<b>ST. CHARLES</b> <small>S I N C E 1 8 3 4</small>	<b>PLAN COMMISSION AGENDA ITEM EXECUTIVE SUMMARY</b>			
	<b>Project Title/ Address:</b>	General Amendment (City of St. Charles)		
	<b>City Staff:</b>	Matthew O'Rourke, Planner		
<b>Please check appropriate box (x)</b>				
	<b>PUBLIC HEARING 2/21/12</b>	<b>X</b>	<b>MEETING</b>	
<b>APPLICATIONS UNDER CONSIDERATION:</b>				
General Amendment				
<b>ATTACHMENTS AND SUPPORTING DOCUMENTS</b>				
General Amendment Application				
Staff Memo				
<b>EXECUTIVE SUMMARY:</b>				
<p>Staff has filed an application for General Amendments to the Zoning Ordinance.</p> <p>Staff has routinely updated the current Zoning Ordinance since its adoption in 2006. Beginning last year Staff decided to present these amendments annually as part of an annual review process. Staff is presenting this year's amendments in the attached memo.</p>				
<b>RECOMMENDATION / SUGGESTED ACTION</b> ( <i>briefly explain</i> ):

**RE:** General Amendments to Tile 17 (Zoning Ordinance)

**DATE:** February 17, 2012

**Project Name:** General Amendments 2012

# Yard Diagram

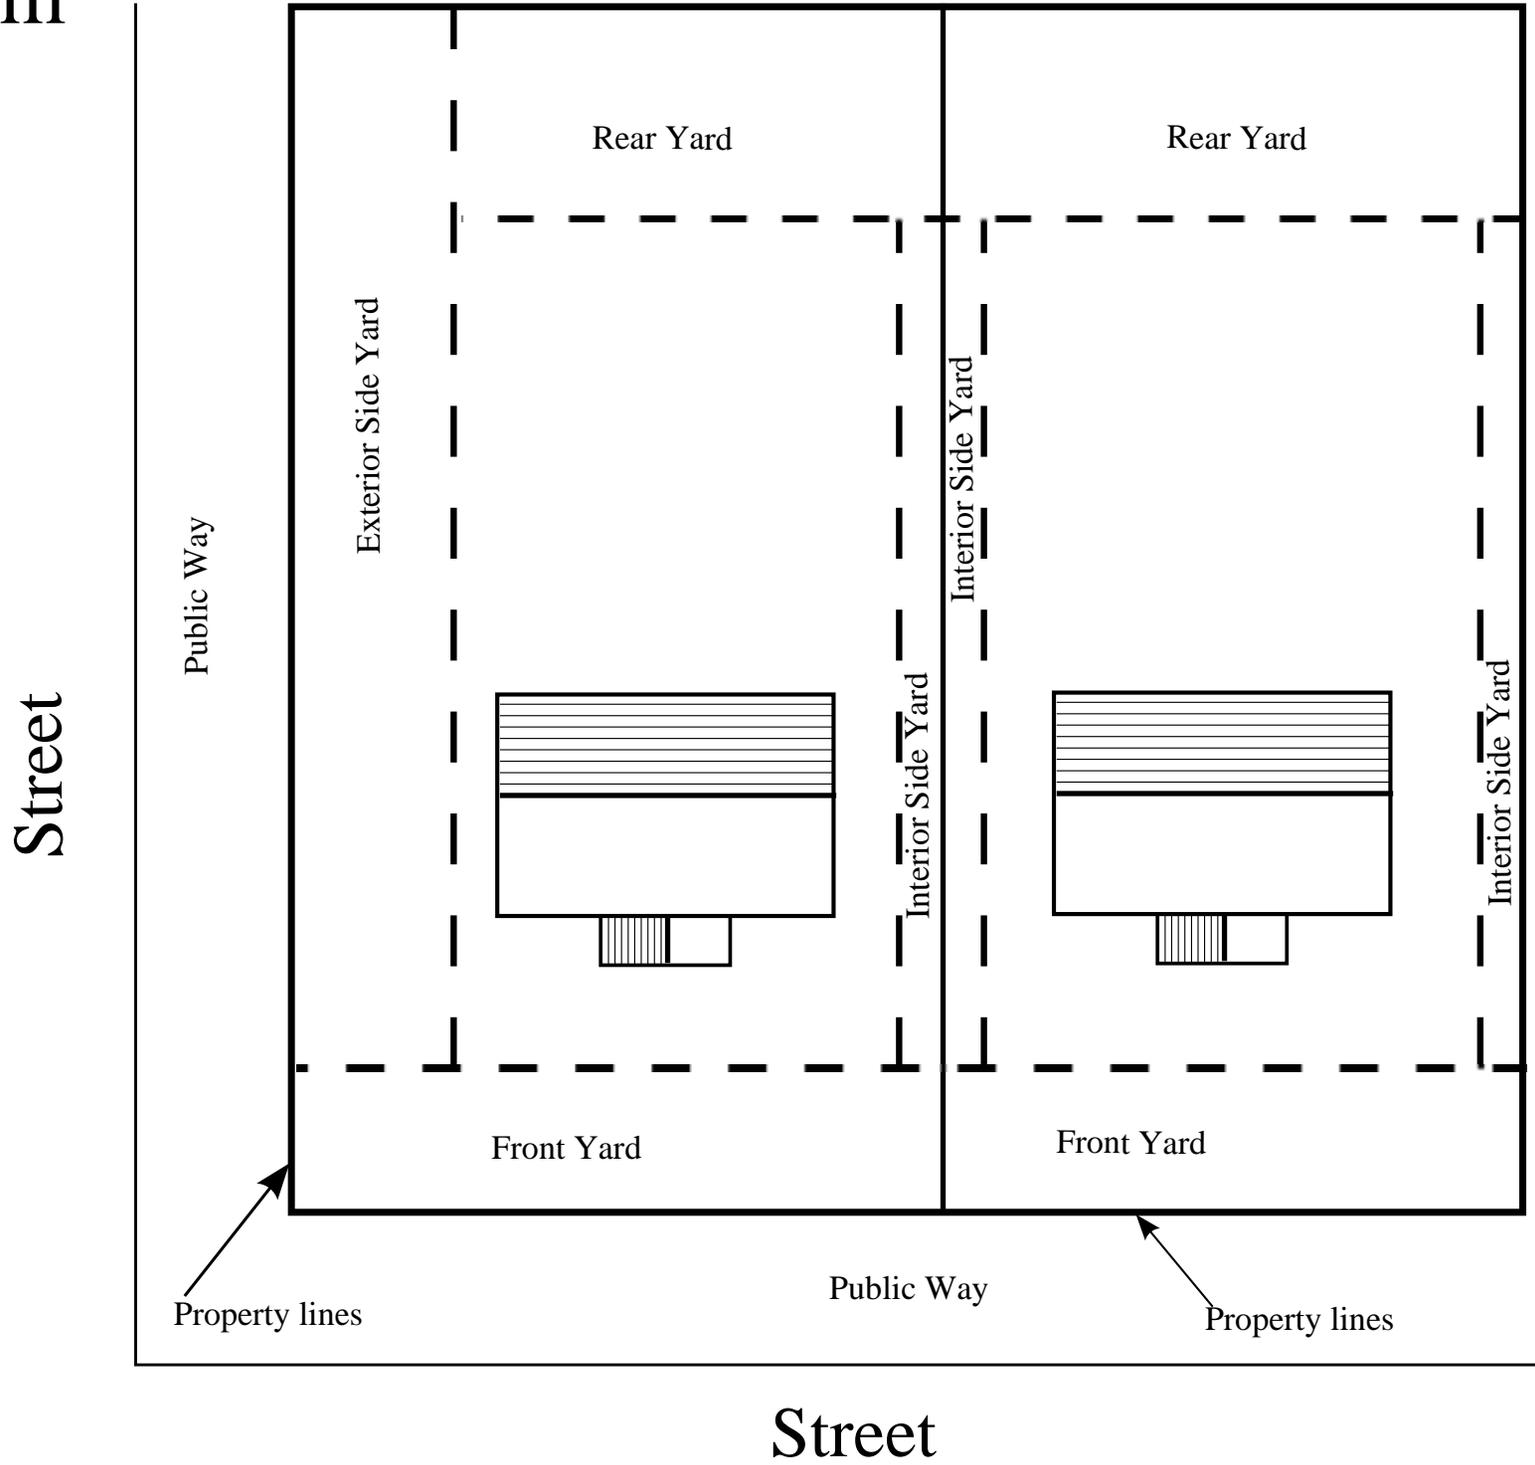
Staff has noticed in the past year that residents and businesses have difficulty identifying yards on their properties; particularly, when trying to locate fences. While front-yard, side-yard, exterior-side-yard are defined in the ordinance, trying to identify the proper location of each yard can become problematic. This is especially evident for properties that are on corner lots.

Staff is proposing to incorporate a new yard-layout-diagram that graphically depicts the location of required yards to assist property owners in determining the location of yards on their property.
